# Staff Report

File Number: 11-E-20-IH

**Location:** 3108 Ocoee Trl. **Parcel ID** 69 M H 029  
**Zoning:** RN-2 (Single-Family Residential Neighborhood)  
**District:** Edgewood Park Infill Housing Overlay District

Level II Changes to Porches Visible from the Primary Street

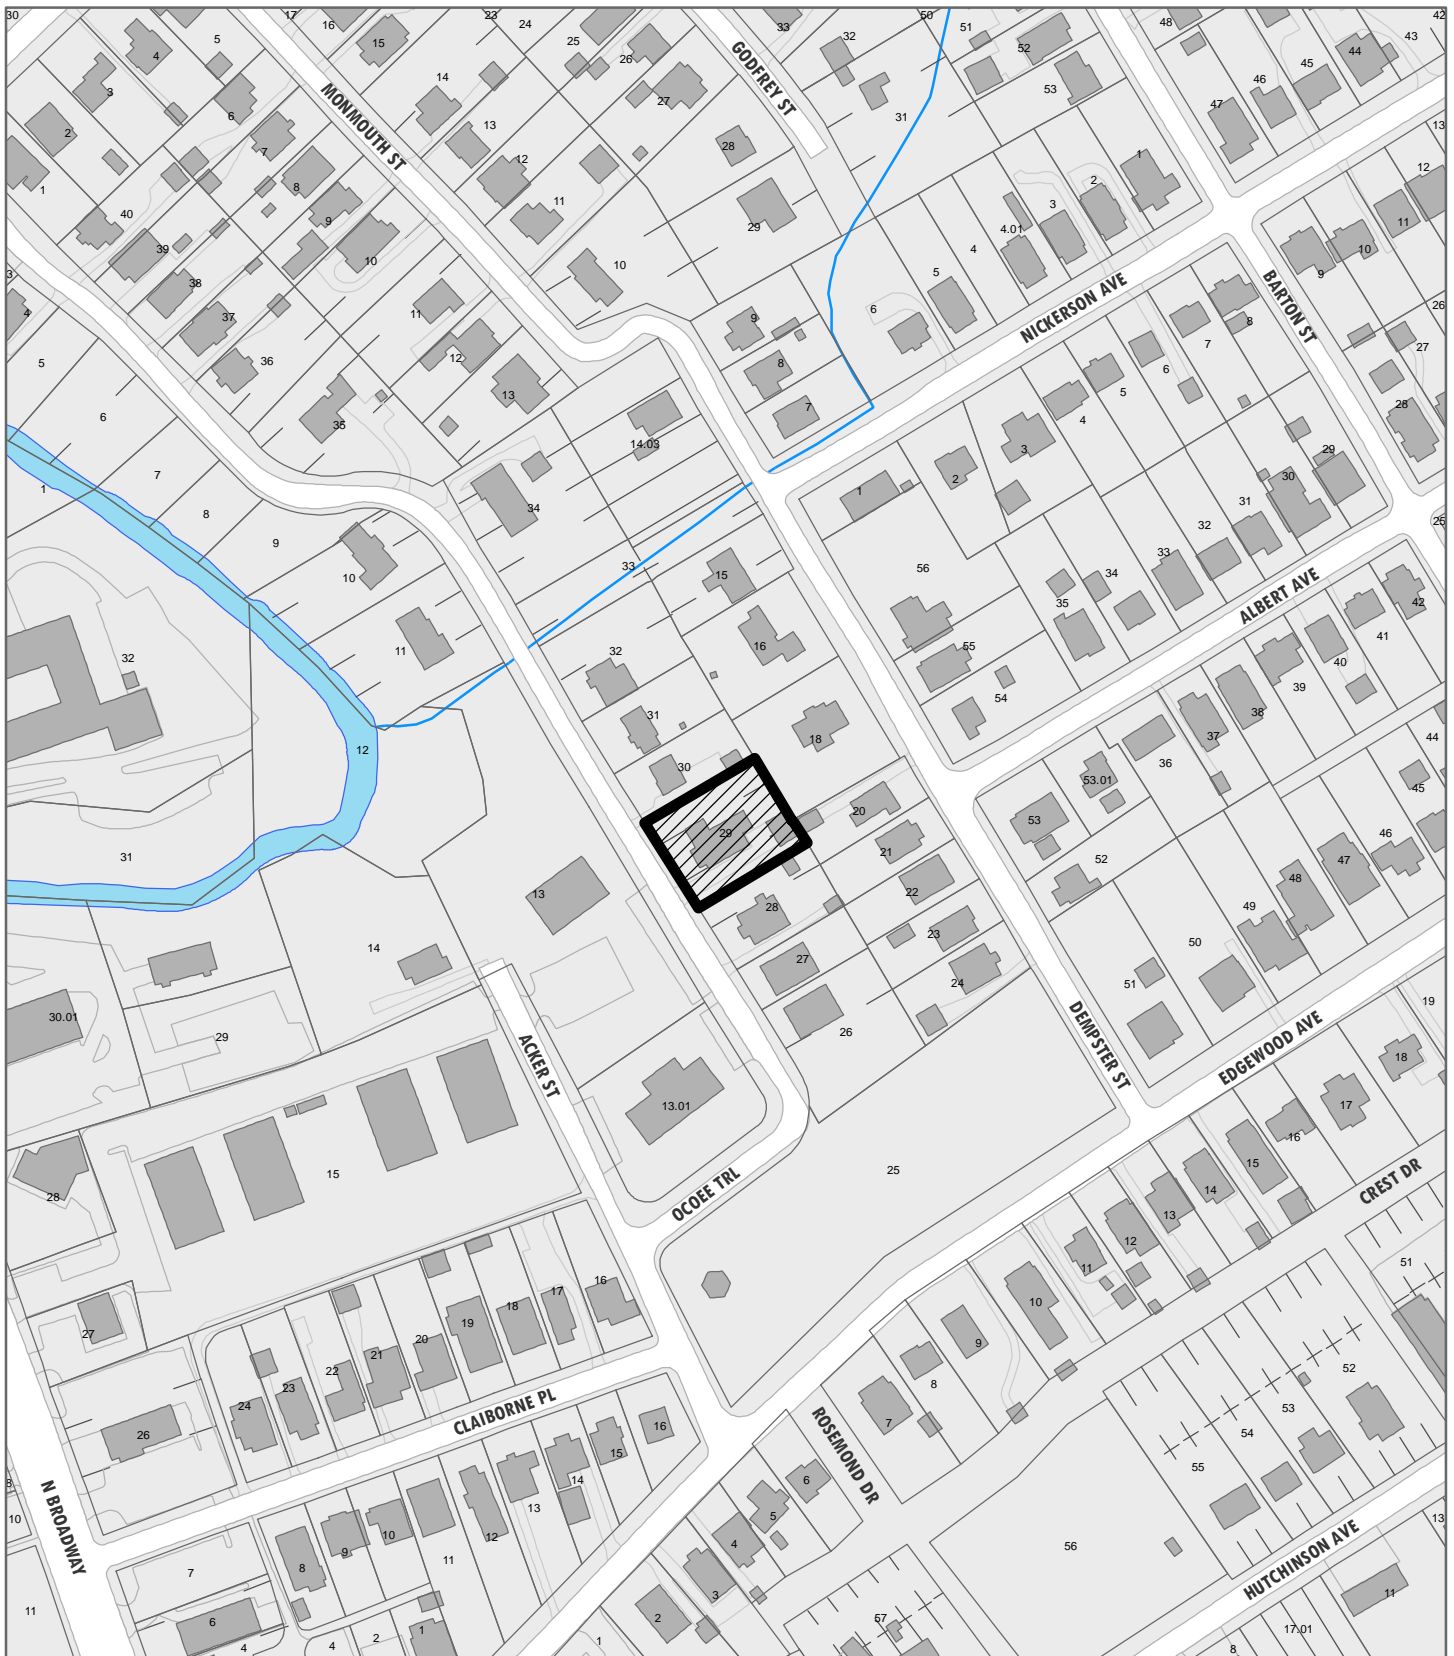
The proposed porch modifications meet the Infill Housing Design Guidelines. The 8" addition to the porch foundation is not disproportionate to the existing house or porch design, will not create additional front setback issues, and will result in the new porch being more proportional to the surrounding block. Proposed materials, including cladding the porch foundation in stucco, are appropriate. The removal of the wrought-iron columns (discouraged in the design guidelines) and replacement with 6" x 6" square wood columns is appropriate within the guidelines. No modifications will be made to the existing porch roof.

Staff recommends approval of the work as submitted.
